12th August 2007

SERVICE BULLETIN SB/EUR/OO2 ISSUE 1 EV-97 teamEUROSTAR UK AIRCRAFT TRIM CABLE CLEVIS PIN RETAINER

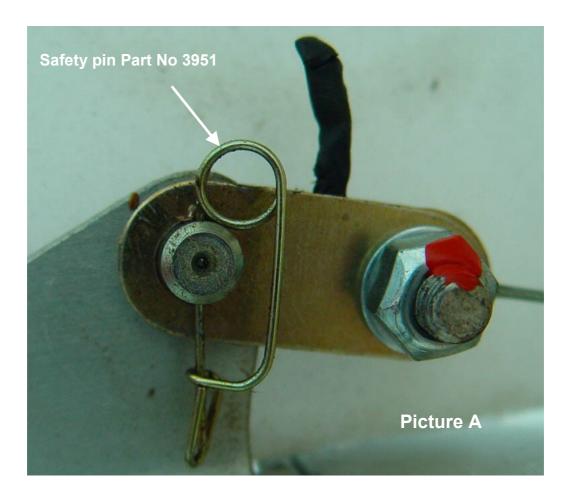
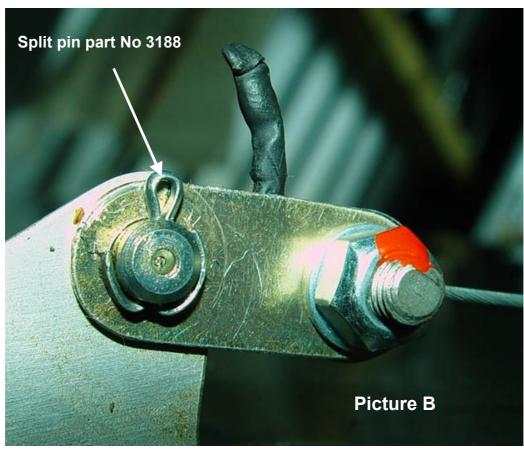
There is a possibility that during cleaning, handling or fitting/removing aircraft covers the safety pin, part No 3951, retaining the trim cable clevis pin to the trim tab horn could become unclipped and fall out. (See picture A)

A normal pre flight inspection should cover this area, but if missed and the safety pin were to fall out and subsequently allow the clevis pin to fall out, loss of the elevator trim control would result.

Remove the safety pin, part No 3951, from the top trim cable clevis pin (picture A) and replace with split pin 2 X14, (part No 3188 available from Cosmik) as per picture B. Bend the ends of the split pin as in the picture to secure the split pin and prevent them being caught by cleaning rags, aircraft covers, ETC.

Repeat the above procedure for the lower trim cable clevis pin.
